**From:** [REDACTED]  
**Sent:** 19/06/2023 10:28:51 AM  
**To:** Council Northernbeaches Mailbox  
**Subject:** DA 2023/0607 173 WHALE BEACH ROAD, WHALE BEACH WRITTEN  
SUBMISSION: LETTER OF OBJECTION SUBMISSION: TULLOCH  
**Attachments:** LIPSON WS.pdf;

a written submission by way of objection

ROBYN LIPSON, 171 WHALE BEACH ROAD, WHALE BEACH

RE: DA 2023/0607  
173 WHALE BEACH ROAD, WHALE BEACH  
WRITTEN SUBMISSION: LETTER OF OBJECTION  
SUBMISSION: TULLOCH

**PLANT SCHEDULE**

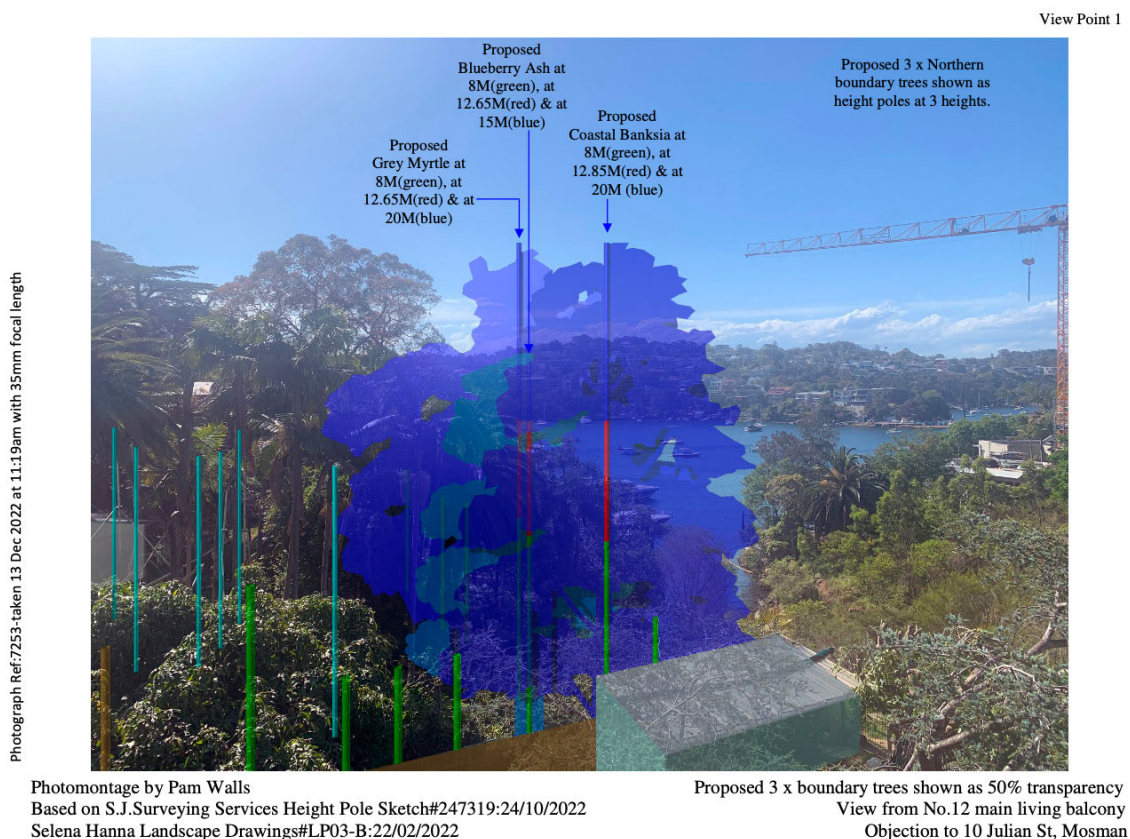
There are 60 proposed trees over 10m in height that could take neighbours views. I attach the schedule from the Landscape Plan.

- Landscaping. To maintain view sharing, the proposed trees and plants over 8m in height shall be deleted in the landscape plan. Tree canopy planting must be located at least 3m from buildings and 5m from common boundaries, to avoid excessive canopy protruding over neighbour's property. An amended Landscape Plan prepared by a qualified landscape designer to a scale of 1:100 and conditions of this Consent shall be submitted to Council's satisfaction with the Construction Certificate. The plan shall show: a north point; existing and proposed finished ground levels; the location of all existing and proposed landscape features; proposed streetscape works adjacent to the property boundary; existing trees to be retained, removed or transplanted (including species and dimensions); and tree protection zones for trees (on or

#### 19. IMPACTS UPON ADJOINING PROPERTIES: PRIVACY

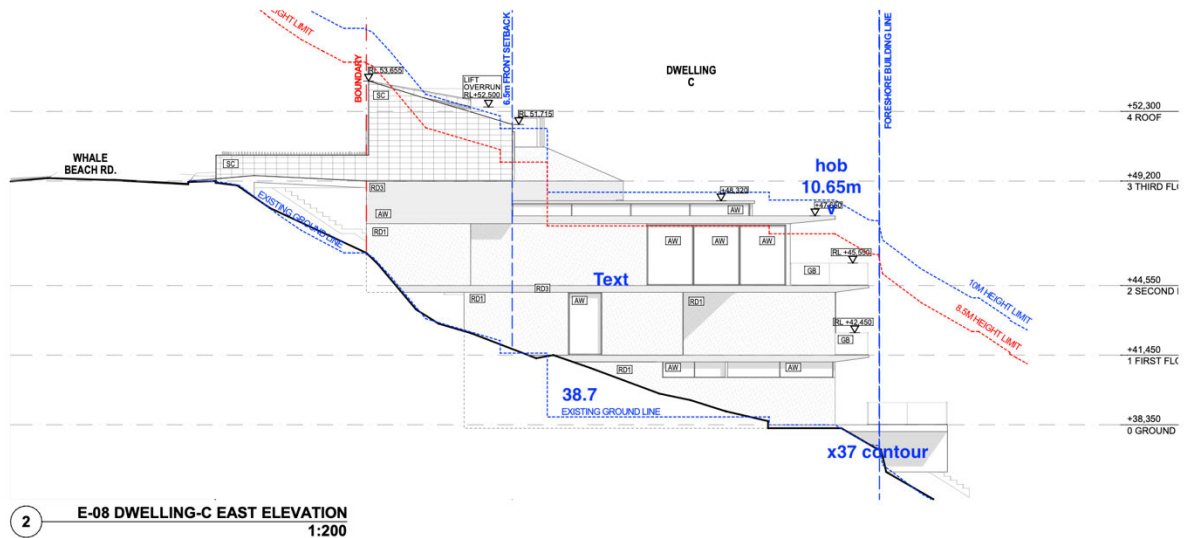
The proposal is contrary to Section 4.15(1)(a)(iii) of the *Environmental Planning and Assessment Act 1979* as it will have unacceptable impacts upon the amenity of neighbours' property, specifically with regard to visual privacy.

The proposed development should be refused as it will have unacceptable impacts upon the amenity of my clients' property, specifically with regard to visual privacy.

Comment: As the development is considered to result in an unacceptable privacy impact due to the design, it is requested that the proposed development be redesigned to reduce amenity impact on the neighbouring properties.
